## **AUSTILL PLACE SUBDIVISION, UNIT FOUR**

APPLICATION NUMBER 23 DATE December 6, 2007

# DETAIL SITE PLAN

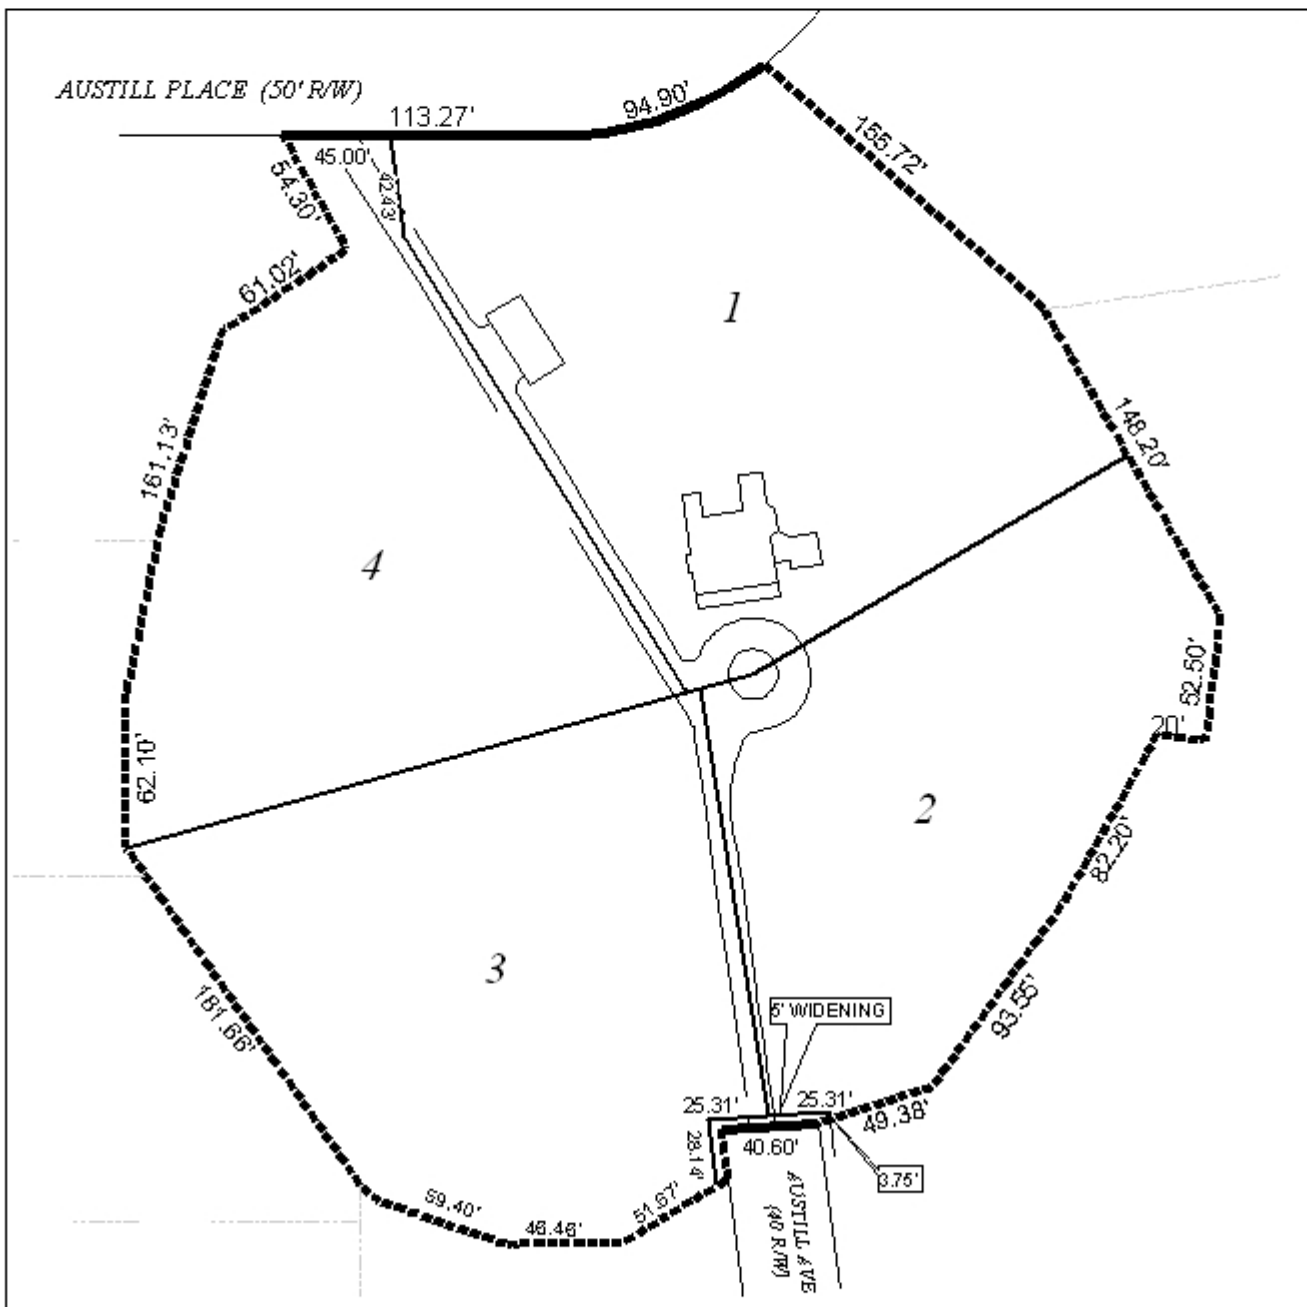
The site fronts onto the terminus of Austill Avenue and onto Austill Place, both minor streets. The right-of-way for Austill Avenue is only 40-feet, which is substandard, and the applicant has indicated a dedication totaling 10 feet, in order to bring the right-of-way width up to minimum standards. It should be pointed out that due to the fact that Austill Avenue dead-ends at the property, and as the street segment exceeds 150-feet, the Mobile Fire-Rescue Department may require compliance with the 2003 International Fire Code, including Appendices B through D, which would require the provision of a 96-foot diameter cul-de-sac (120-foot right-of-way) or other approved turn-around.

Proposed Lots 2-4 will have less than 60-feet of frontage on a public street, thus a waiver of Section V.D.2. would be required. Due to the limited frontage that Lots 2-4 have on a public street, each lot should be limited to one curb-cut each, with the size, design and location to be approved by Traffic Engineering, and in compliance with AASHTO standards.

The minimum building setback line is not depicted on the plat, but will be required. The minimum building setback line should be depicted where each lot is a minimum of 60-feet in width, and/or at least 25-feet from existing or to be dedicated right-of-way.

Finally, it appears that drainage from the site is to the Southwest, thus any new development on the proposed lots may exacerbate drainage problems experienced by the homes fronting Carmel Drive East. Full compliance with the City of Mobile storm water and flood control ordinances will be required for any new development, including paving.

- 1) Compliance with Engineering comments, and placement of the comments as a note on the plat (*No water can be concentrated onto an adjacent property owner without a release agreement. All storm water should tie subsurface to a City of Mobile storm drainage system. If the cumulative impervious area constructed since 1984 is equal to or greater than 4000 square feet, storm water detention is required. It is the responsibility of the applicant to look up the site in the City of Mobile (COM) GIS system and verify if NWI wetlands are depicted on the site. If the COM GIS shows wetlands on the site, it is the responsibility of the applicant to confirm or deny the existence of wetlands on-site. If wetlands are present, they should be depicted on plans and/or plat, and no work/disturbance can be performed without a permit from the Corps of Engineers. Must comply with all storm water and flood control ordinances. Any work performed in the right of way will require a right of way permit.*);

- 3) Revision of plat to reflect any compliance with the 2003 International Fire Code, including Appendices B through D, with local amendments, determined necessary by Mobile Fire-Rescue for fire apparatus turn-around (approved cul-de-sac or hammer-head), or provision of a letter from Mobile Fire-Rescue stating that the provision of a fire apparatus turn-around is not required, prior to the signing of the final plat;

- 4) Placement of a note on the final plat stating that each lot is limited to one curb-cut each, with the size, design and location to be approved by Traffic Engineering, and in compliance with AASHTO requirements;

- 5) Depiction of the minimum building setback line where each lot is at least 60-feet in width, and/or at least 25-feet from existing or to be dedicated right-of-way;

- 6) Placement of a note on the final plat stating that no future subdivision of Lots 2-4 is allowed until additional frontage on a public street is provided; and

- 7) Labeling of each lot with its size in square feet.
